ADDENDUM TO  
SPECIFICATIONS ENTITLED  
"WARDLAW COLLEGE AND DRAYTON HALL  
HVAC EQUIPMENT AND ROOF REPLACEMENT  
UNIVERSITY OF SOUTH CAROLINA  
COLUMBIA, SOUTH CAROLINA  
PROJECT NO. H27-6100"

**ADDENDUM NO. 1**

**April 30, 2015**

Enclosure: Photo  
Sign-In Sheet

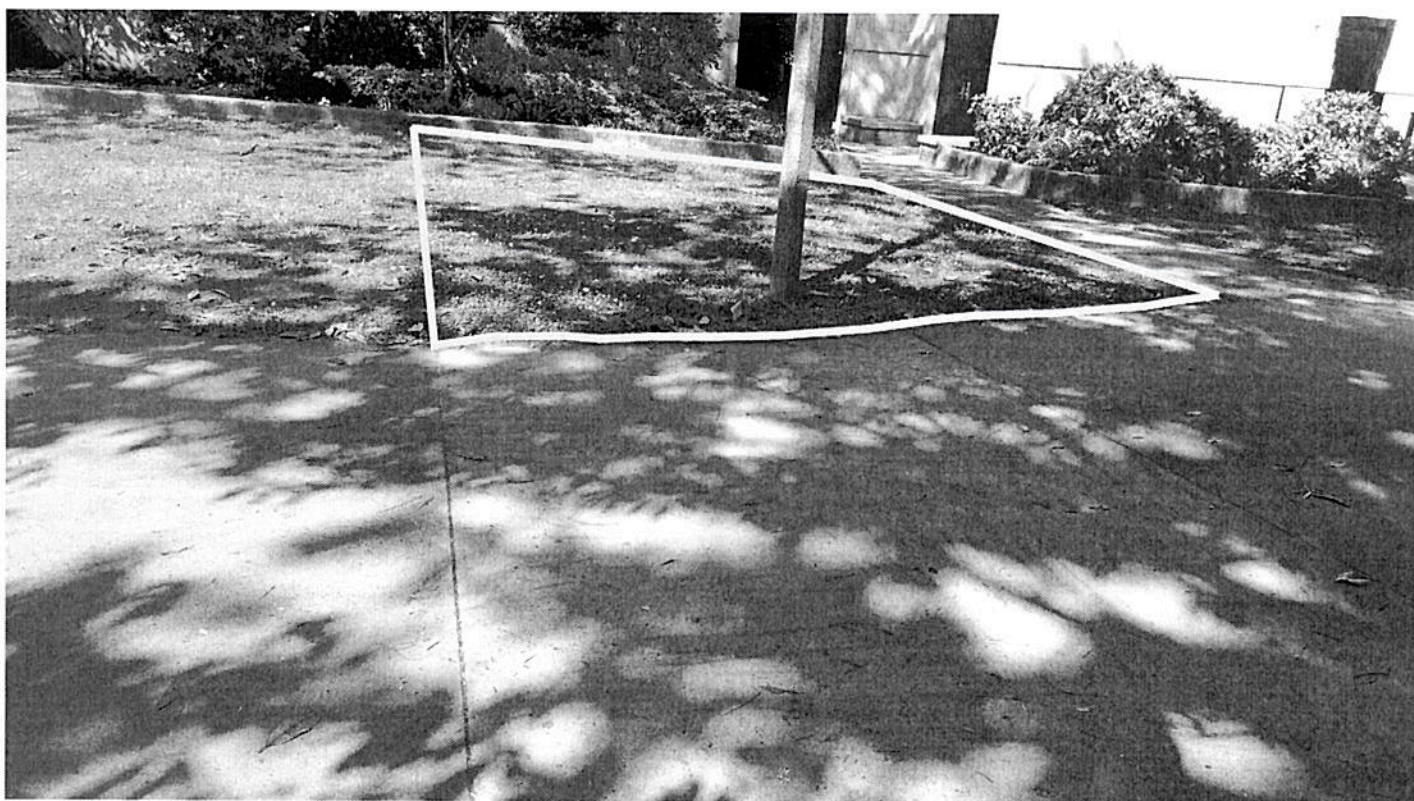
- b. Egress must be maintained at all times during the project.
9. Grounds must be protected at all times. Take whatever means necessary to protect the grounds. A photo has been attached with designated areas of the landscape that can be encroached.

- a. All sidewalks and remaining landscape will have to be protected.
10. USC's dumpster will be removed allowing the contractor to place their dumpster in its place. This will be allowed with the agreement that the building can use the contractors dumpster while theirs is removed.
